AMTA Submission

Australian Communications & Media  
Authority

Review of the 700 MHz band spectrum  
licence technical framework—  
Consultation paper

**Figure 1—TV transmitter sites using either Channel 49 and/or 50**

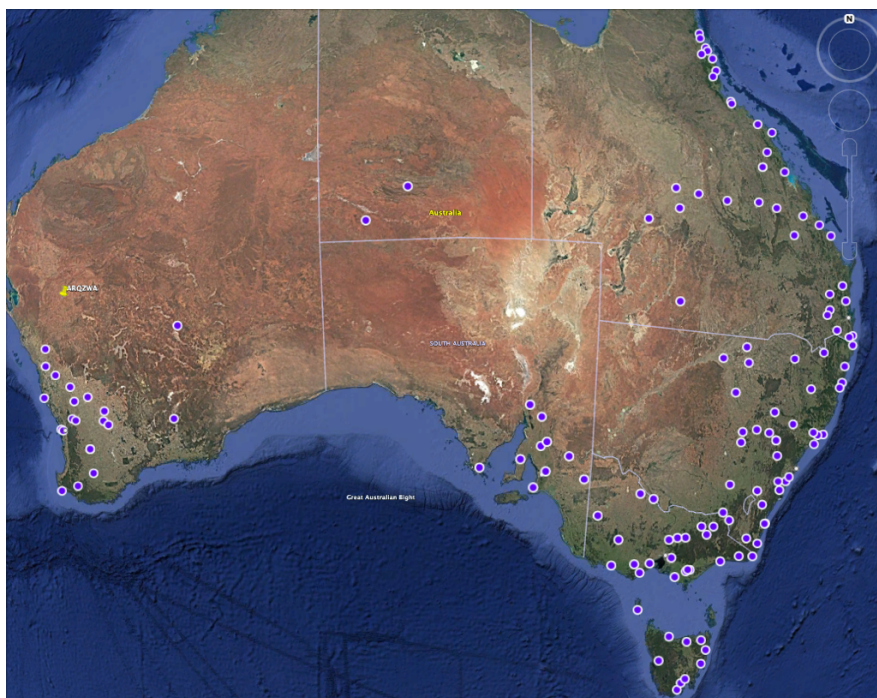
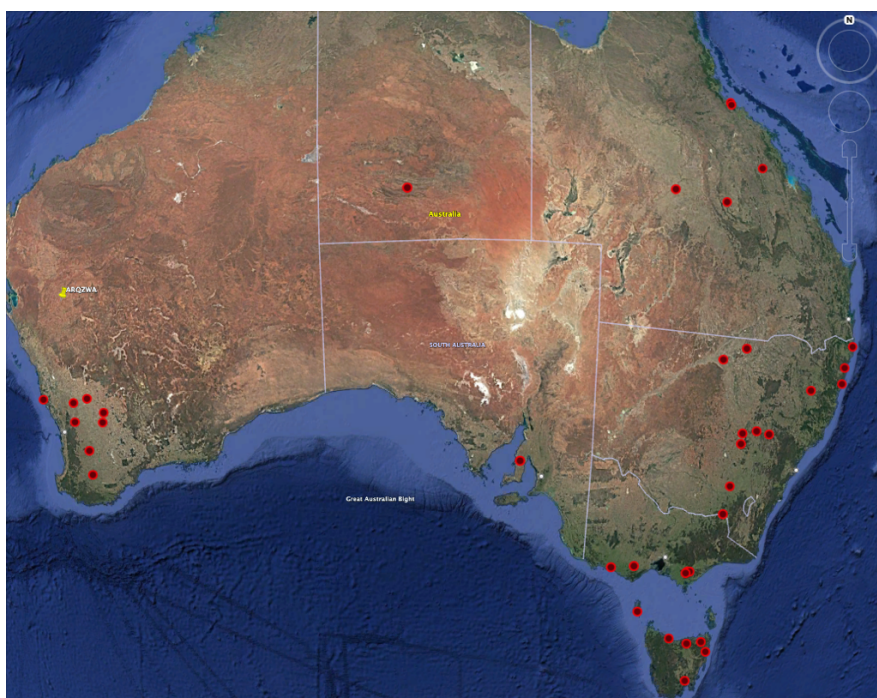
It is perhaps convenient that this highest-risk channel (51) is by far the least-used TV channel within Block E. There are only 38 licences on Channel 51, far fewer than the 118 licences on Channel 50. Below is a Figure showing all Block E sites either/both of Channels 49 and/or 50, followed by a Figure showing the Block E sites using Channel 51. In the ACMA's coverage maps<sup>1</sup> (presumably "best server" areas), the larger coverage areas of Dalwallinu WA, Swan Hill VIC and Nhill VIC do not use Ch 51; the only high power service using Ch 51 is Mt Ulandra (service SW Slopes/East Riverina). Similarly, other populated areas served by Block E services—like Gold Coast, Sunshine Coast and Toowoomba—do not use Ch 51. **None** of the in-fill services in the State capital cities use Ch 51.

**Figure 3— AMTA proposed revised unwanted emission limits for 700 MHz upper band (base station) transmitters above 803 MHz—preferred option.**

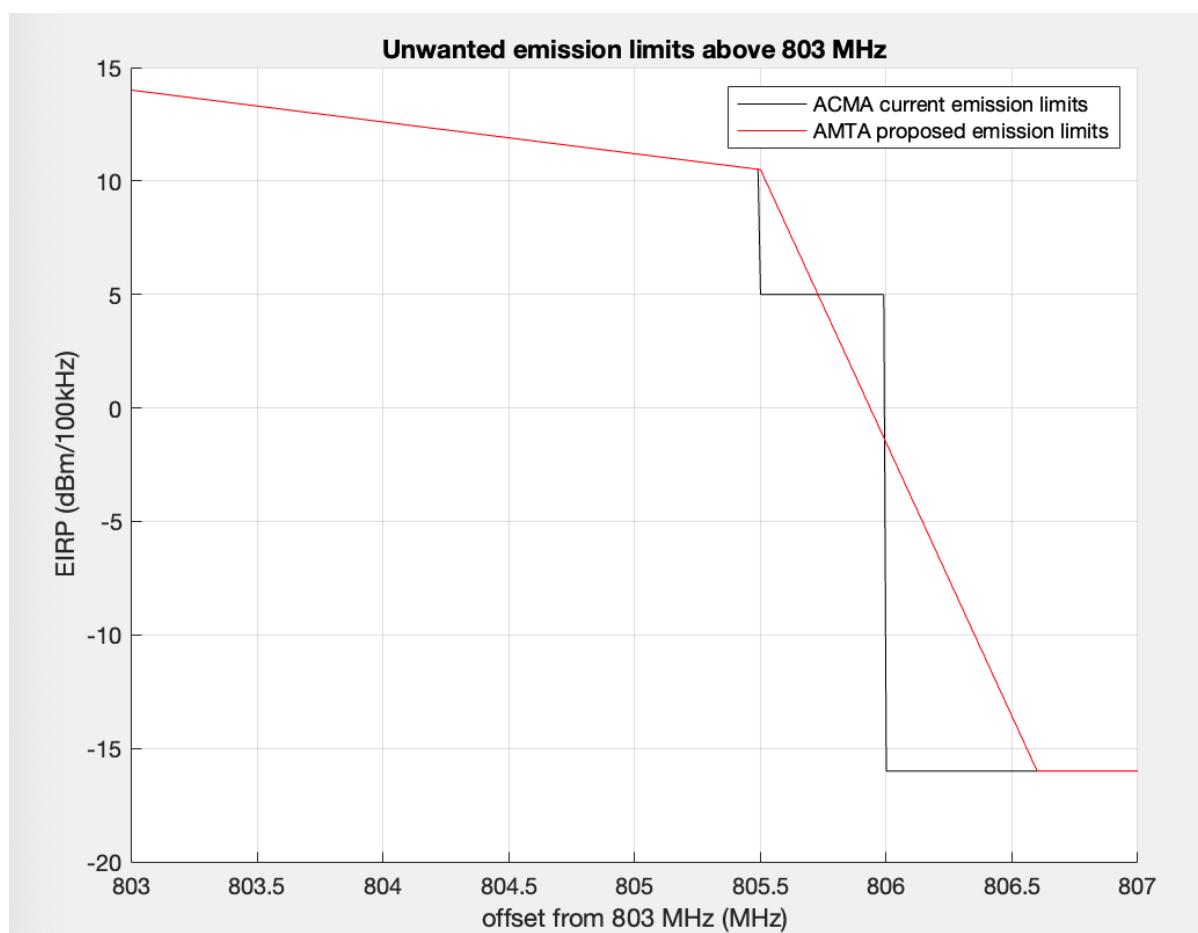
Notably, this results in a sharp drop from +61.2 dBm/MHz EIRP<sup>2</sup> in-band to -6 dBm/MHz EIRP (a total of almost 70 dB) within just 3 MHz of the operating band upper edge. This is particularly challenging for vendors to comply with.

Apart from the costs of having to design, manufacture and implement bespoke solutions for Australia—which are ultimately passed onto the consumer—one of the main concerns is power consumption. Adding an additional filter resonator and moving it closer to the passband increases insertion loss which needs to be compensated by running the transmitters at slightly higher power—this has both environmental impacts and increases costs associated with power consumption. These challenges would be significantly eased by a slight relaxation in the unwanted emission mask. The relaxation would also allow new radios—designed and implemented with a view to meet the relaxed limits versus the current—to be smaller and lighter (which relaxes requirements for tower strength and wind-loading), more energy-efficient, and be available on the market sooner.

To balance the benefits to MNOs and vendors with the theoretical increase in interference potential to trunked land mobile services (TLMS) above 806 MHz, we request that the limits for unwanted emissions above 805.5 MHz be reviewed. We suggest a sloped limit from +20.5dBm/MHz EIRP at 805.5 MHz<sup>3</sup> to -6 dBm/MHz EIRP at 806.6 MHz.

AMTA’s proposed unwanted emission limits above 803 MHz require no changes to the ACMA’s proposed limits in Tables 5 and 6 on pg 20 of the consultation paper, and would only require a couple of simple changes to the table titled Table 7 in the consultation paper, as follows:

Frequency range (f)	Radiated maximum true mean power (dBm EIRP)	Measurement bandwidth
805.5 MHz ≤ f < 806.6 MHz	$10.5 - 26.5/1.1 * (f_{\text{offset}} - 2.5)$	100 kHz
806.6 MHz ≤ f < 813 MHz	-6	1 MHz

**Figure 4—AMTA proposed revised unwanted emission limits for 700 MHz upper band (base station) transmitters above 803 MHz—fallback option.**

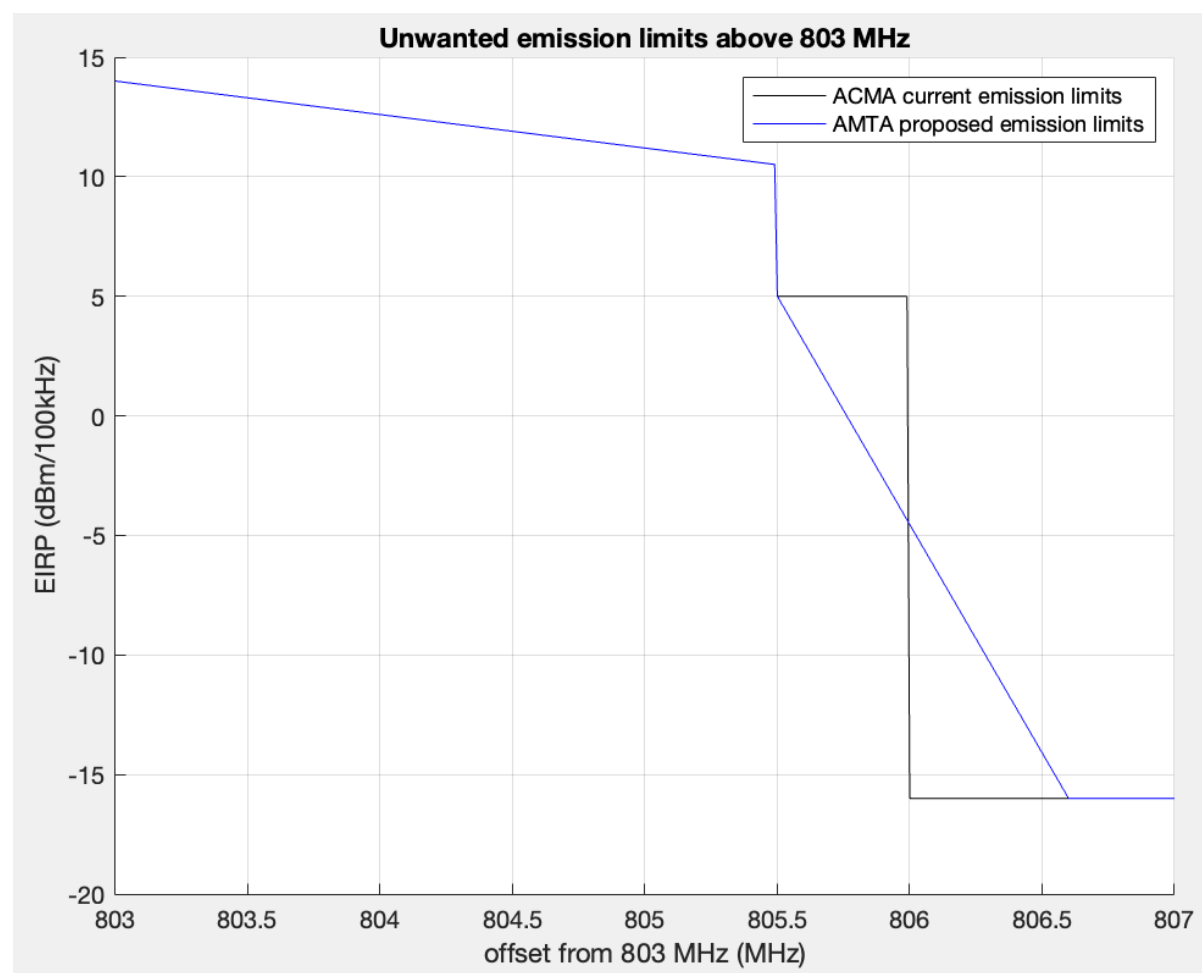
If the ACMA is still concerned about increasing the unwanted emission limits within 805.5-806 MHz—despite our justifications in the next section below—and prefers to ensure that the unwanted emission limits within this 0.5 MHz range are not altered, then we propose a fallback option involving a sloped limit from +15 dBm/MHz EIRP at 805.5 MHz<sup>4</sup> to -6 dBm/MHz EIRP at 806.6 MHz.

Frequency range (f)	Radiated maximum true mean power (dBm EIRP)	Measurement bandwidth
805.5 MHz $\leq f < 806.6$ MHz	$5 - 21/1.1 * (f_{\text{offset}} - 2.5)$	100 kHz
806.6 MHz $\leq f < 813$ MHz	-6	1 MHz
